RE: Additional Investigation Workplan
Alaska Gas
6211 San Pablo Avenue
Oakland, California

Re: **Additional Investigation Workplan**
Alaska Gasoline Company
6211 San Pablo Avenue
Oakland, California
Case #RO0000127

Subject: Site Conceptual Model and Site Characterization for Fuel Leak Case RO0000127,
GeoTracker Global ID T0600101804, Alaska Gas Station, 6211 San Pablo Ave.,
Oakland, CA 94608

DRAWING NUMBER:
FIGURE 2

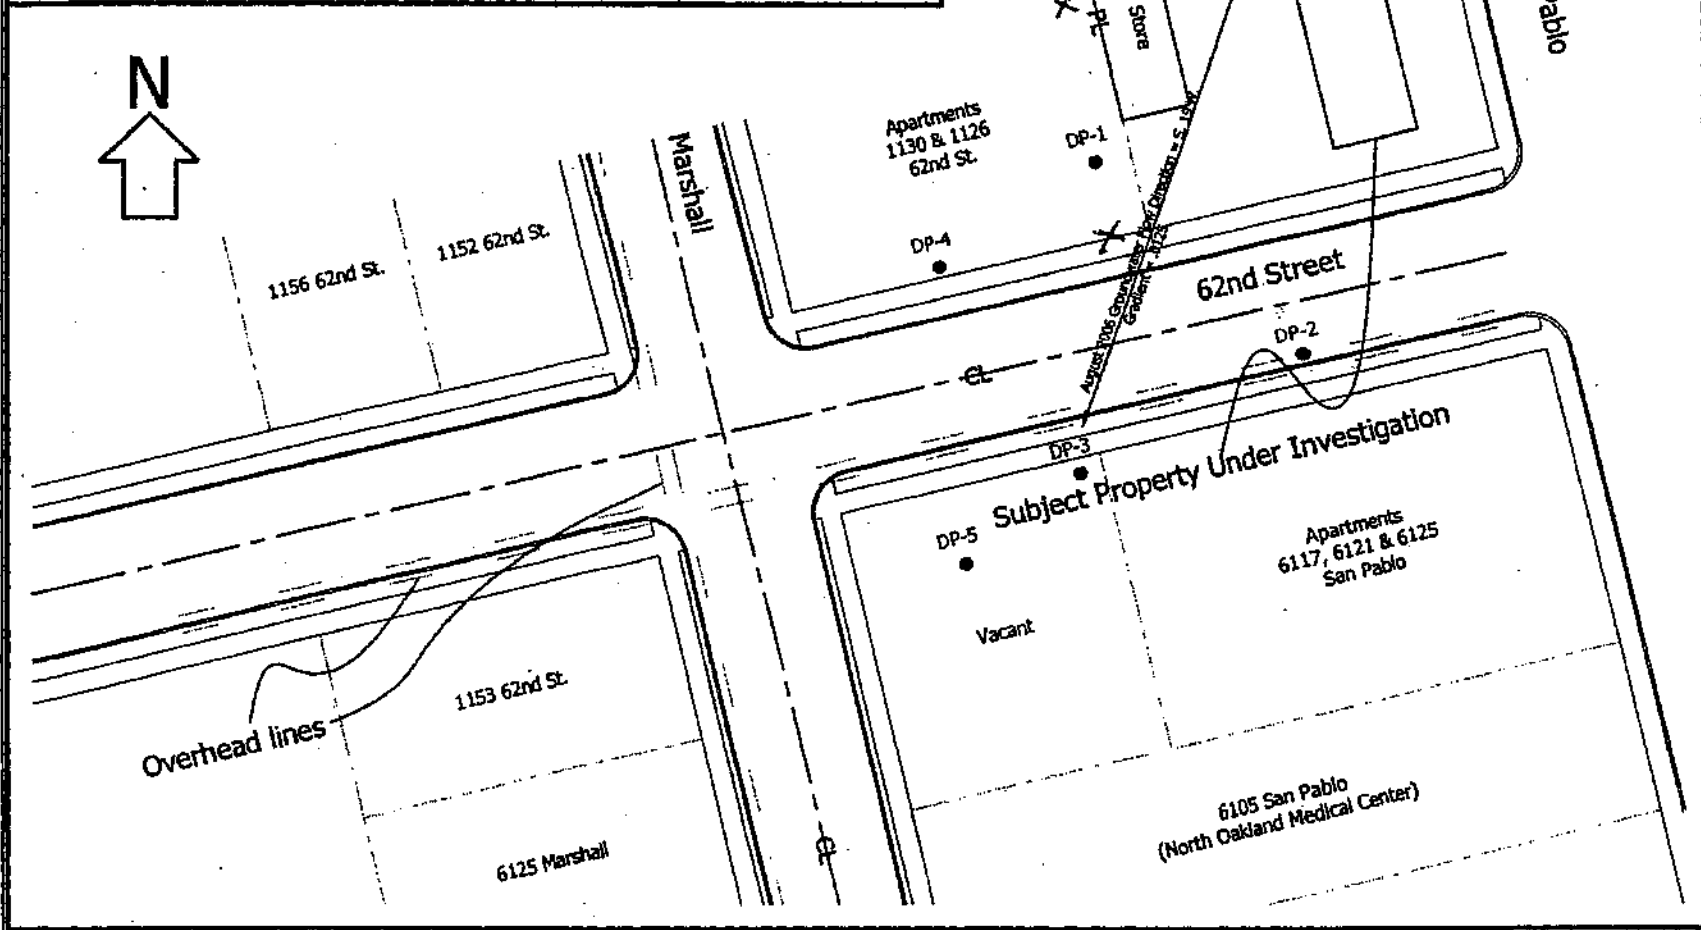
3. Although we concur with the direct push soil and groundwater proposal, we request that you observe the following:
 - All the proposed borings should be drilled. We believe the plume cannot be defined by only three borings as inferred in the work plan.

- Two additional borings are recommended in locations immediately down-gradient of areas impacted with free product. I have marked these locations with (x) on the attached Figure 2.
